PD Modification Application: MM 25-1243

**Hillsborough
County Florida**

Development Services Department

AGENCY REVIEW COMMENT SHEET

8.2 Proposed Site Plan (Full) page 1 of 2

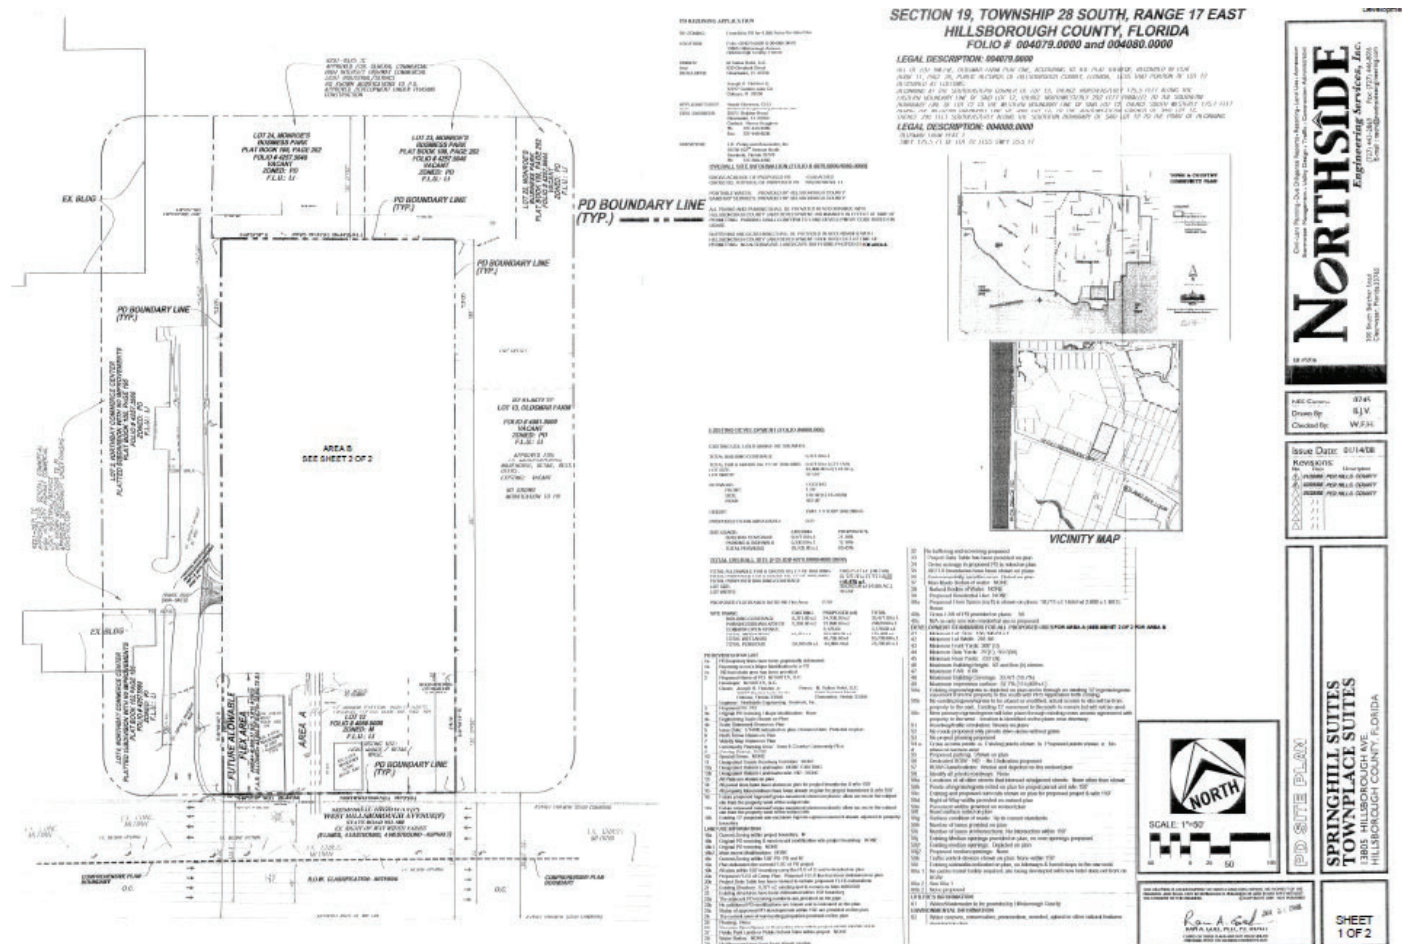
The applicant requests a Planned Development (PD) variation from LDC Section 6.06.06 – Landscaping and Buffering, which requires a 20-foot buffer with Type B screening along the north and west property boundaries and a 20 to 30-foot buffer with Type B or Type C screening along the east. Per the LDC requirements for a type A screening, evergreen plants, at the time of planting, shall be 6-foot-high evergreen shade trees. The applicant instead proposes a 10-foot buffer with screening consisting of 10-foot-high evergreen shade trees (2-inch caliper) planted 20 feet on center (as currently required).

The proposed access modifications are intended to bring the project into compliance with current access management and multimodal connectivity standards. The addition of a vehicular and pedestrian access along the northwest boundary and a pedestrian gate along the south MM 25-1243 boundary.

1. add a vehicular and pedestrian cross access north of (and in addition to) the approved access along the western boundary,
2. change the approved vehicular and pedestrian to a pedestrian only access to Parcel A within the PD zoning, and
3. add a pedestrian cross access to the east.

Staff finds the proposed variation supportable. To the north, existing wetlands and vegetation separate the site from commercial buildings oriented away from the project. To the west, a retail use and associated parking areas create over 130 feet of separation with existing tree cover. The east side adjoins a vacant parcel approved for stormwater use, offering approximately 170 feet of natural vegetated separation, while to the south, structures within the same PD are set back about 50 feet and share internal circulation areas.

7. There shall be on ~~the west side of the property, excluding lot 12 parcel folio 4080.0000,~~ a 10-foot wide buffer along the north, east and south boundaries of the area subject to MM 25-1243, and an 8-foot wide buffer along the west boundary of the area subject to MM 25-1243, to include a row of evergreen shade trees which are not less than ten feet high at the time of planning, a minimum of two-inch caliper, and are spaced not more than 20 feet apart.

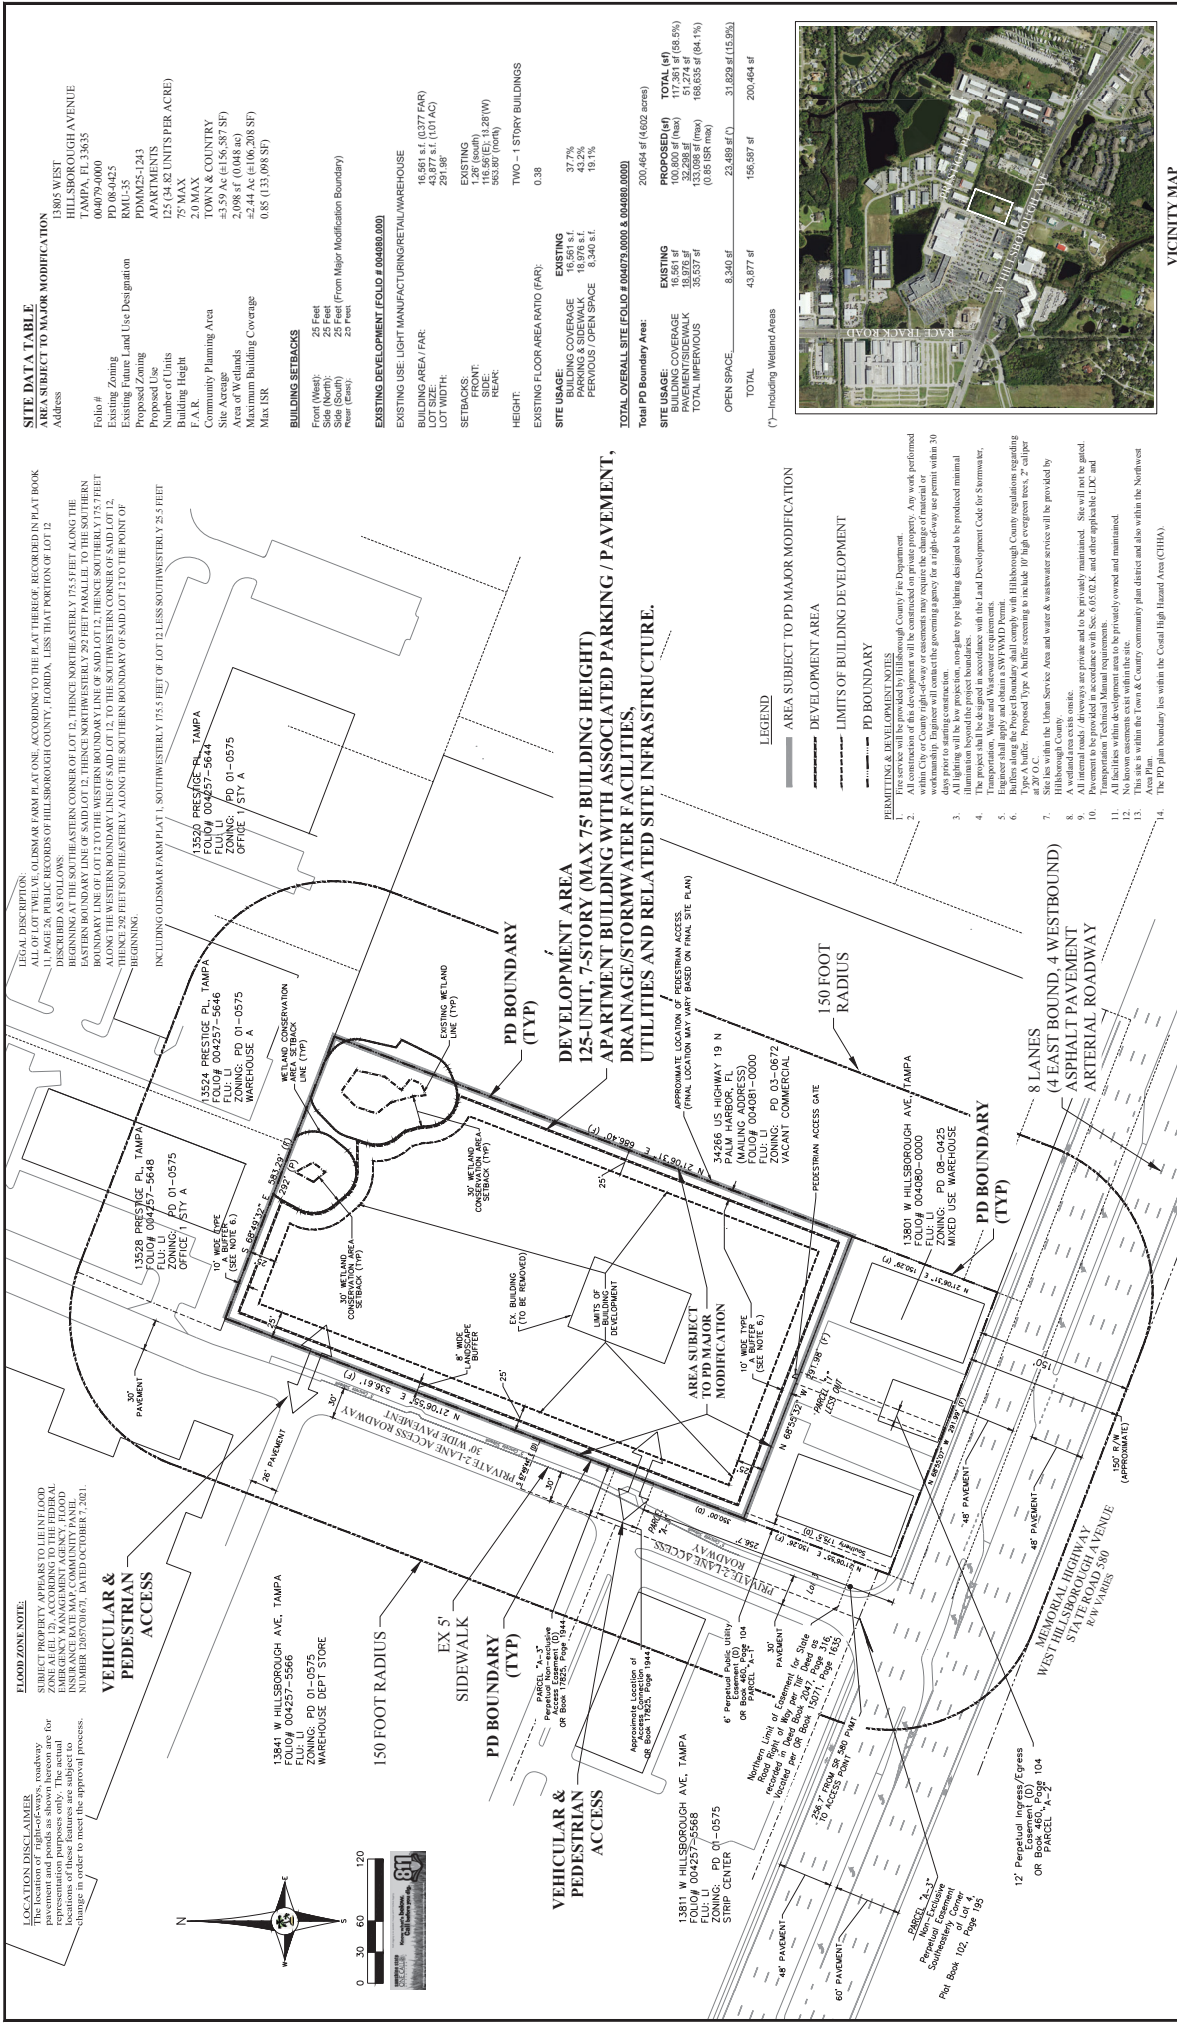
As the driveway from Hillsborough Avenue to the proposed multi-family residential units, as shown on the PD site plan, exceeded the maximum length allowed pursuant to County Land Development Code (LDC), Section 6.04.04.A.2. of 250 feet for residential developments, the applicant's Engineer of Record (EOR) submitted a Section 6.04.02.B Administrative Variance request (dated October 10, 2025). Based on factors presented in the Administrative Variance request, the County Engineer found the request approvable (on November 6, 2025).

The subject property is under review for the PD rezoning process, as is shown on the attached **PD Site Plan**. This variance is to request that the driveway length to serve this development can exceed the maximum 250 feet per Section 6.04.04.A.3. criteria of driveway length.

This PD project needs access to this existing private driveway and the main access connection to this private driveway serving this PD site aligns with the existing frontage road driveway connection to the west. The length of this driveway connection serving this PD site from Hillsborough Avenue to the point of connection is 256.7 feet (See **Aerial Exhibit** attached). There will be a need for this driveway to continue into the site to serve the proposed building, which may be another 60 to 70 feet, for a total driveway length of approximately 330 feet.

If this rezoning is approved the County Engineer will approve the Administrative Variance Request to allow the project driveway to exceed the 250-foot length to a total of +/-330 feet from Hillsborough Ave. to the multi-family residential units.

I have found the attached Section 6.04.02.B. Administrative Variance (AV) for PD 25-1243 APPROVABLE.
